RE: Walser Toyota Exterior-LSI10423

CASE #PL2021-42

LIGHTING PROPOSAL

RE: Walser Toyota-Parking Garage / Bloomington, MN / LO-153155

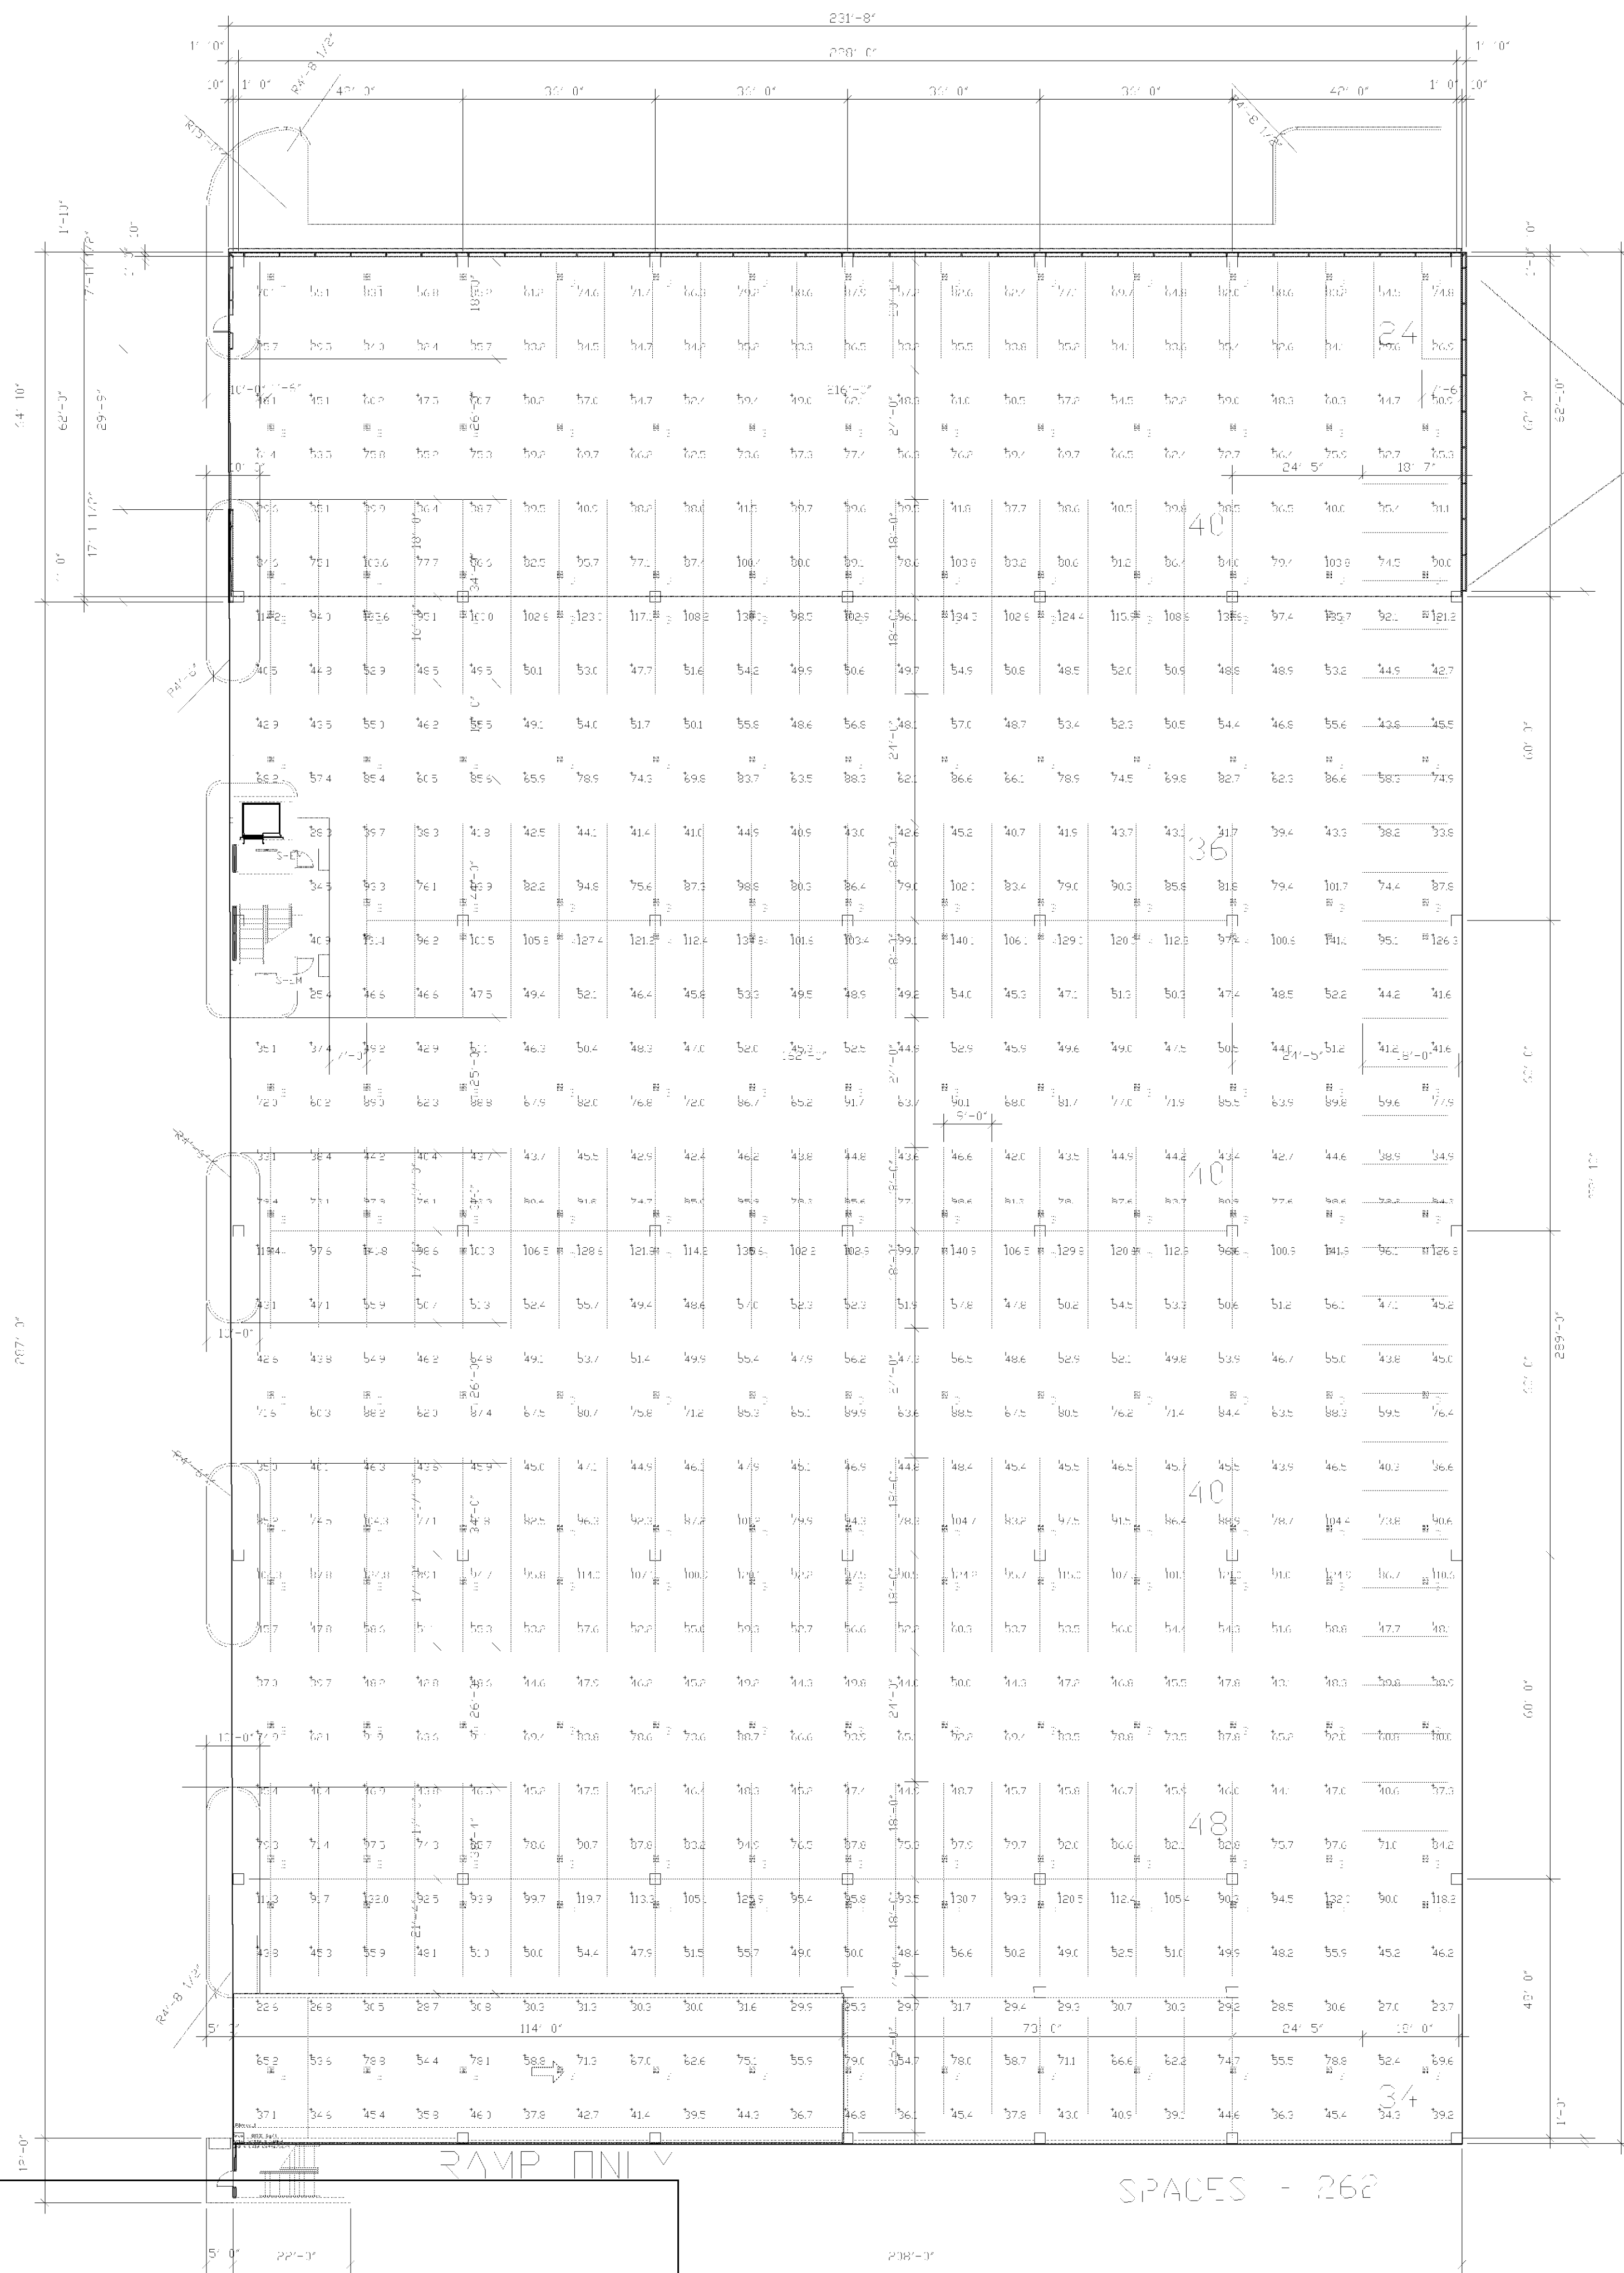
Per your request the lighting calculations generated by LSI for the above mentioned project have been checked. This calculation was generated using AGi32 software from Lighting Analysts. Luminaire locations and mounting heights were provided by LSI and noted accordingly on the luminaire schedule. Maintained readings (LLF=.81) AND initial readings (LLF=1.0) are taken at 4 ft above grade as is typical for auto dealerships calculated by LSI. The building in the center were built as blocking objects. The calculation process was generated in direct-mode which means that no reflectances were considered.

Several statistical areas were created for parking spaces within the parking lot and labeled accordingly and shown in the calculation summary.

A D sized pdf file and full-sized dwg file has been provided for the site for both the maintained and the initial LLF calculations. I reviewed this calculation as a Lighting Certified professional by NCQLP and can be found on the LC registry at www.ncqlp.org

WALKER TOWNS
GROUND FLOOR PKG
BLOOMINGTON, IN

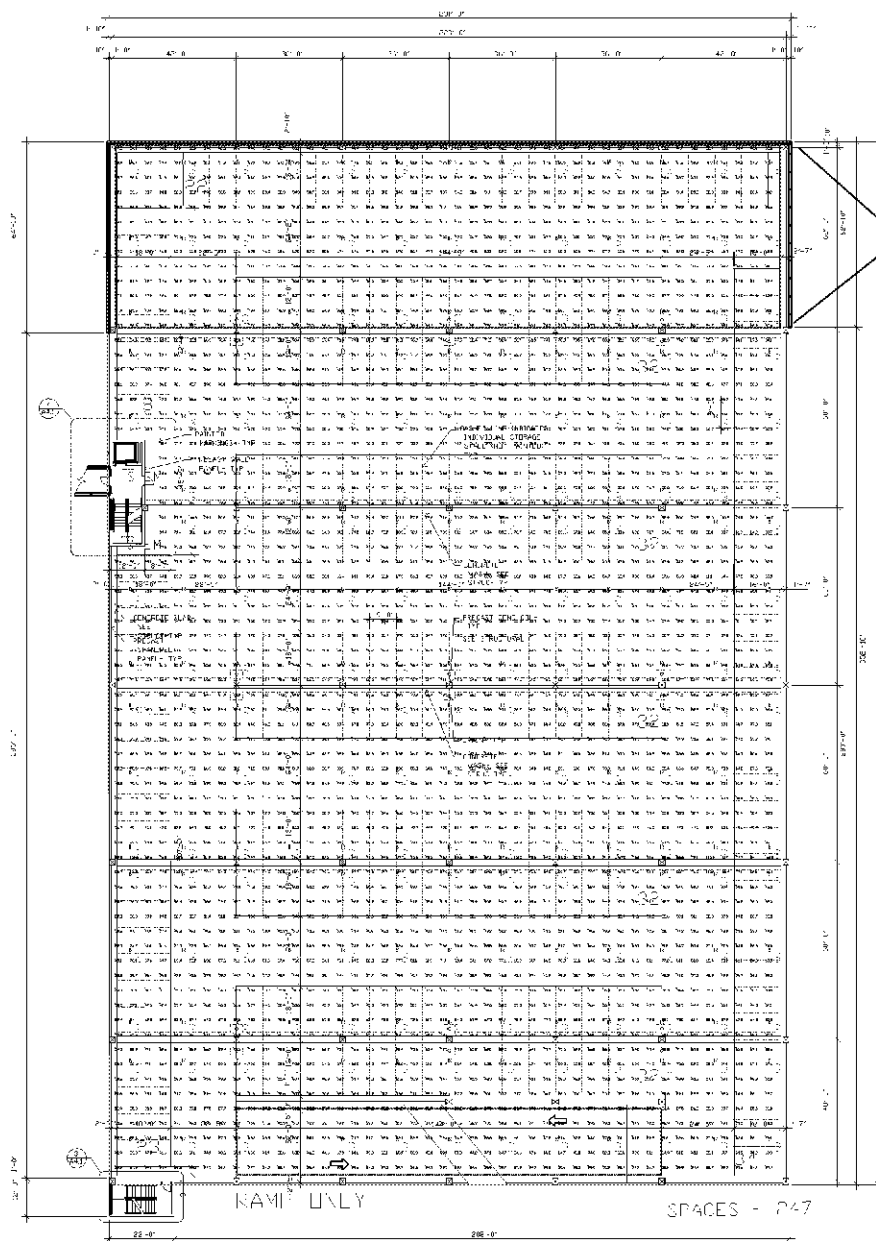
Per your request, the lighting calculations generated by LSI for the above mentioned project have been reviewed and verified. The calculations were generated using AGI32 software from Lighting Analysts. Luminaire locations and mounting heights were provided by LSI and noted accordingly on the luminaire schedule. All calculated light levels are at grade level. The calculation process was generated in full radiosity mode and reflective surfaces were considered. Four layouts were created in total, and specifics about each are noted below.

LO-153155-10C-Ground Floor was run at Initial
LO-153155-10C-1st & 2nd Fl was run at Initial
LO-153155-11B-Ground Floor was run using a 0.81 light loss
LO-153155-11C-1st & 2nd Fl was run using a 0.81 light loss factor

A "D" size pdf file and full-sized dwg file have been provided for each of the four layouts. I have reviewed the calculations as a Lighting Certified professional by NCQLP and can be found on the LC registry at www.ncqlp.org
